# Work Order ID 83085

Item Name: Crosstube Aft

DRAWING NO. D212-664-241	TITLE CROSSTUBE ASSY (205/212 HI AFT)	REV. D	DART AEROSPACE LTD ENGINEERING ORDER		D.E.O. NO. D212-664-241-D-1	SHEET NO. SHEET 1 OF 2	SCALE NTS
DRAWN	CHECKED	MFG. APPR.	APPROVED	DE APPR.			
DATE 11.04.07	DATE 11.04.11	DATE 11.04.12	DATE 11/04/12	DATE 11.04.12

DRAWING NO. D212-664-241	TITLE CROSSTUBE ASS'Y (205/212 HI AFT)	REV. D	<b>DART AEROSPACE LTD ENGINEERING ORDER</b>		D.E.O. NO. D212-664-241-D-2	SHEET NO. SHEET 1 OF 1	SCALE NTS
DRAWN 92	CHECKED ASS	MFG. APPR. [Signature]	APPROVED [Signature]		DE APPR. [Signature]		
DATE 11.07.15	DATE 11.07.20	DATE 11.07.21	DATE 11/27/21		DATE 11.07.21

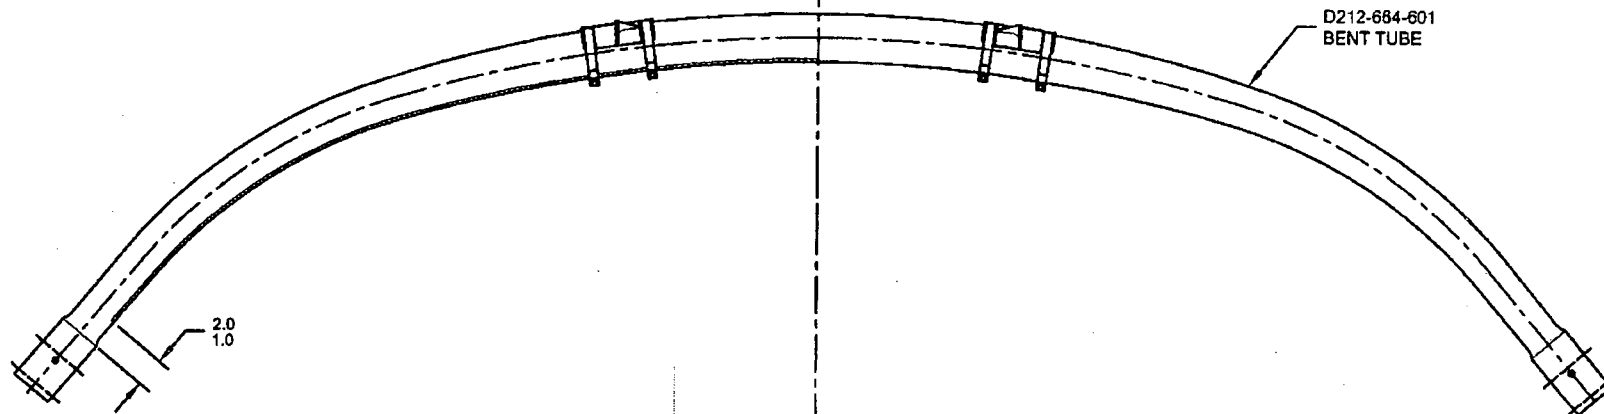
ADD AN INSPECTION WINDOW TO UNDERSIDE OF CROSSTUBE.

NOTES 2 OF SHEET 1 IS AMENDED AS FOLLOWS:

- 2) FINISH: CHEMICAL CONVERSION COAT PER DART QSI 005 4.1  
PRIME INSIDE AND OUTSIDE PER DART QSI 005 4.2  
MASK UNDERSIDE OF CROSSTUBE AS SHOWN (HATCHED AREA) AND  
PAINT OUTSIDE PER DART QSI 005 4.2  
REMOVE MASKING AND APPLY CLEAR COAT

MASK AREA PRIOR TO PAINTING,  
REMOVE MASKING AFTER PAINT  
AND APPLY CLEAR COAT

**FIGURE 1: SUPPORT INSTALLATION**

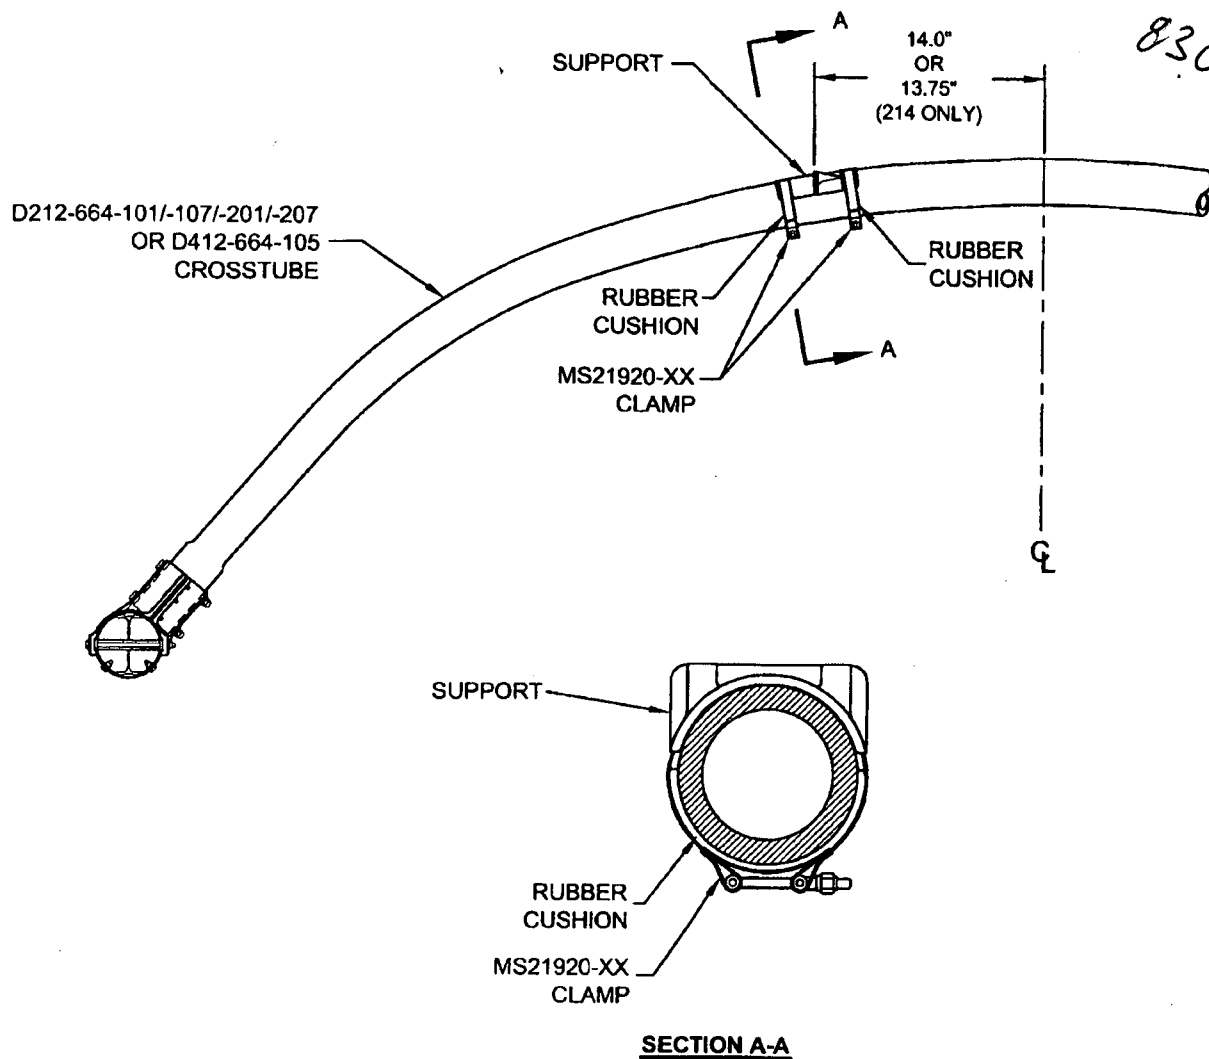
For the crosstubes listed above, section 32.4 of ICA-D212-664 is amended as follows. Use Figure 1 of this service instruction and Figures 32-2 to 32-9 of ICA-D212-664 for further reference. For crosstubes of an earlier change number, it is recommended that if the supports are removed, the supports should be reinstalled using the procedure listed below.

- 32.4.1 Locate the area on the crosstube for installation of support (see Figure 1 of this service instruction). For D212-664-101/-107/-201/-207 and D412-664-105 crosstubes, the outward face of the support tabs should be 14.0" (355mm) from the crosstube center for 204/205/210/412/UH-1 aircraft. For installation on 214B/B-1 aircraft, the outward face of the support tabs should be 13.75" (349mm). Ensure paint finish of crosstube is intact; touch up as required per Chapter 5 (5.3.9) of ICA-D212-664.

- 32.4.2 If present, remove any paint/primer on bottom of supports. Abrade mating surfaces of support and crosstube with 400-grit sandpaper. Saturate a clean cloth with MEK or 4105S Wash'n'Wipe Degreaser or equivalent and wipe until there is no residue.

- 32.4.5 Apply a 0.04" to 0.07" thick layer of Proseal 890 Class B or AMS-S-8802 Class B sealant underneath applicable support and install support as shown in Figure 1 of this service instruction.

- 32.4.6 Install the clamps opposite to crosstube support as shown in section A-A of Figure 1. Install rubber cushions underneath each clamp around the bottom circumference of the crosstube up to the crosstube centerline. Torque clamps 80-100 in-lb (9.0-11.3 Nm). It is acceptable to use smaller or larger sized MS21920-XX clamps than those listed in ICA-D212-664, ensure that after torquing the clamps per this instruction, the nuts are in safety but not bottomed out
